Product change notification (PCN)

Affected products STL 950/..-5.0-V(H)-all Colors (-HC) | STLZ 950/..-5.08-V(H)-all Colors (-HC)
 STL 950/..G-5.0-V(H)-all Colors (-HC) | STLZ 950/..G-5.08-V(H)-all Colors (-HC)
 STL 950/..F-5.0-V(H)-all Colors (-HC) | STLZ 950/..F-5.08-V(H)-all Colors (-HC)

Effective date May 1, 2023

OLD		NEW
Open variants		Open variants
Closed variants		Closed variant
Flange variants	Flange variants

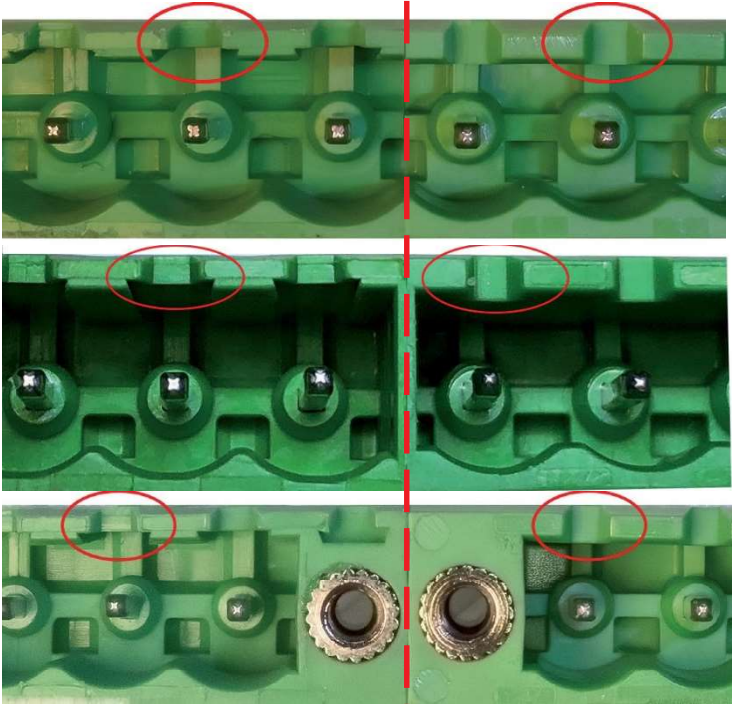
Details - Coding grooves changed
 - Change for all color variants

Coding star K2 RD Article no. 12003.9	Coding star K5 RD Article no. 14310.4
